ADDENDUM NO. 1

Project Name: Demolition of 1200 37th Street

Bid Number: 2020026

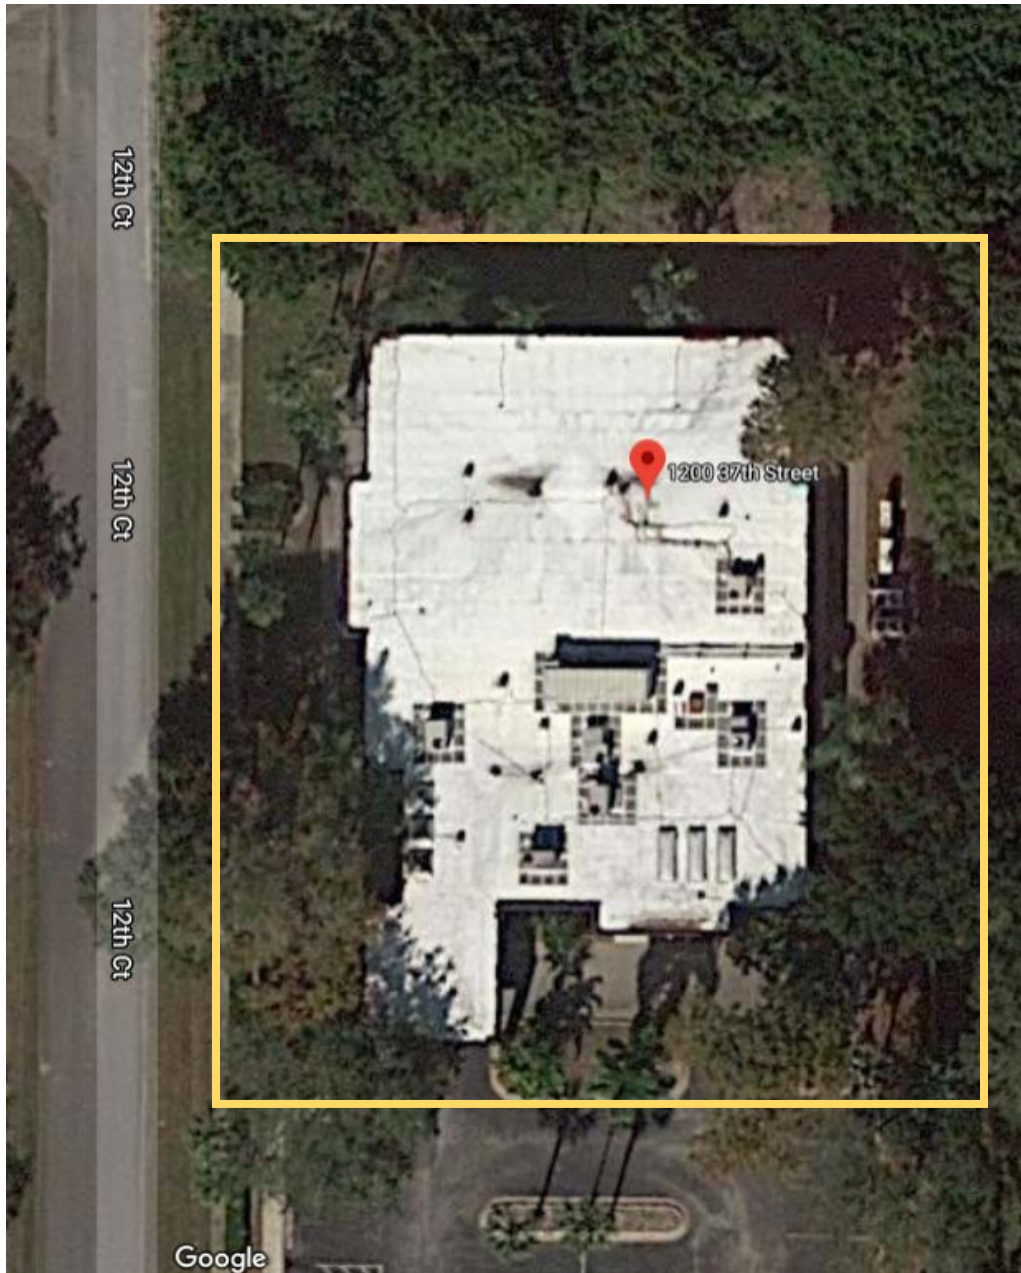
The extent of tree removal was discussed and an overview of the boundaries for tree removal is provided on the following page. The boundaries are:

- Within the sidewalk on the west side;
- within the concrete cut line on the south side;
- to the shrub line on the east; and,
- to the vegetation on the north (three trees in this area).
